PLANNING COMMISSION STAFF REPORT

Alder-Robinson Subdivision – Amending the Amended Plat of the Arcadia Heights Plat A Subdivision

Case #PLNSUB2010-00044

PRELIMINARY SUBDIVISION PLAT – CITY DEPARTMENT REVIEW

Preliminary Plat

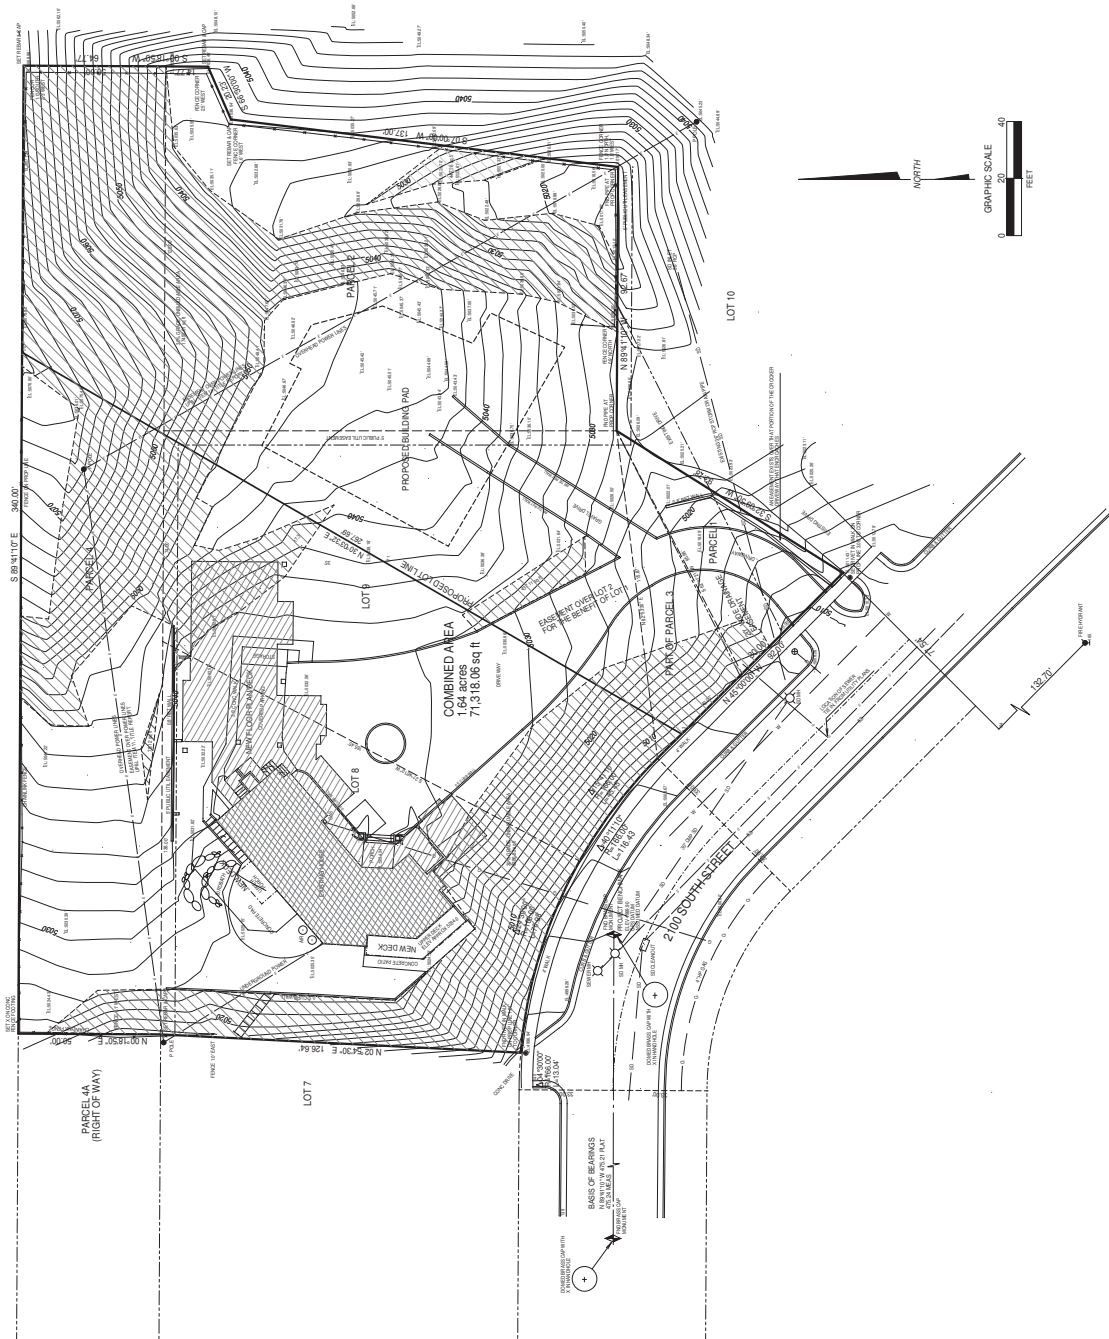
Analysis: The preliminary plat shows a five foot public utility easement running through the building pad on Lot 2. According to a title report submitted by the applicant, there are no utilities currently located within this easement. The applicant will need to work with the City Department of Public Utilities and other local utility companies to either relocate or abandon the easement. This would be a condition of final plat approval.

Analysis: The Transportation Division has expressed concern with the driveway access to Lot 2. The concern relates to the steepness of the driveway grade (see Department/Division Comments, Attachment D). The applicant will need to provide documentation to the City that the building pad for Lot 2 can be accessed according to the City's driveway standards as a condition of final plat approval.

Department/Division: Public Utilities
Reviewer: Jason Brown
Phone: 483-6729
Review Comments: The existing meter for Lot 1 is located along the frontage of the proposed lot 2. Lot 2 must provide an easement for the water service lateral and meter for Lot 1 or the meter must be relocated along the frontage of Lot 1.

In reviewing the existing conditions, there are some concerns for the driveway development to comply to current design standards. Per the submitted grading plan the existing drive is at 18 – 22% slope from back of city sidewalk, with no transitions or staging area. The existing gravel drive, presumed access to the new building pad for lot 2 is at 25%+ slope. We recommend that

an access grading study be presented showing driveway access compliance to current city design standards in order to establish a building pad elevation and show the grading impact required to develop this proposed site. Driveway grades are to be an average of 16% with 6% transitions over an eleven foot run. The drive approach can be at 8% maximum grade from the flow line to the property line.

Portions of the proposed additions to the house on Lot #1 encroach into the undevelopable or nonbuildable areas, which are not allowed per 21A.24.040.G of the Zoning Ordinance. Also, all buildings must be set back a minimum of ten feet from these areas.

The plat shows a 5 foot public utilities easement bisecting the building pad on Lot #2. This will present a problem to develop the lot and it should be relocated.

The note on the driveway, "Easement over Lot 2 for the benefit of Lot 1", may need to be described more fully for recordation purposes.
